INSTALLATION BULLETIN 113

Revision 1
1 August, 2005

Subject: Correction to the AIU configuration and wiring diagram between the AIU and the Century 2000 autopilot.

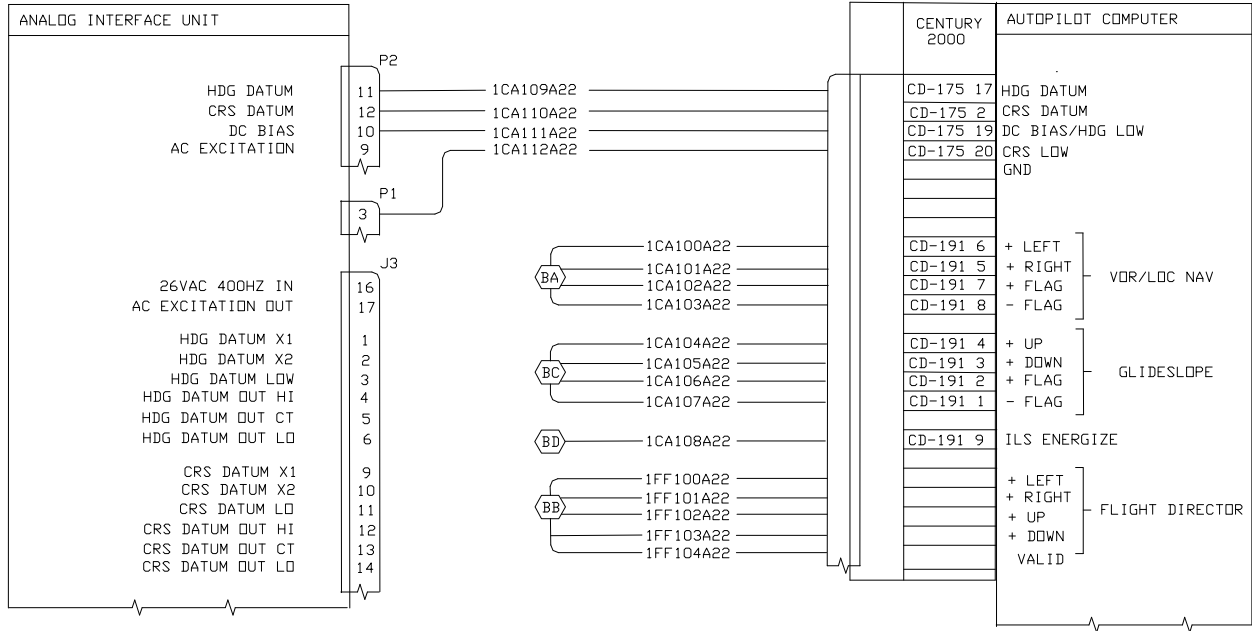
An error has been found in the AIU configuration table and wiring diagram showing interconnect between the AIU and the Century 2000 autopilot. The DIP Switch settings for Heading and Course Gain were set too high, and the associated scaling required adjustment. The wrong pin was designated for DC Bias on the Century 2000 autopilot and has been corrected as shown below.

The AIU to Century 2000 interface wiring should be as follows:

NOTE: The Century 2000 autopilot references the following pins:

CD-175 Pin 19 “Heading/Course Select”

CD-175 Pin 20 “Heading/Course DC Excitation Ground”
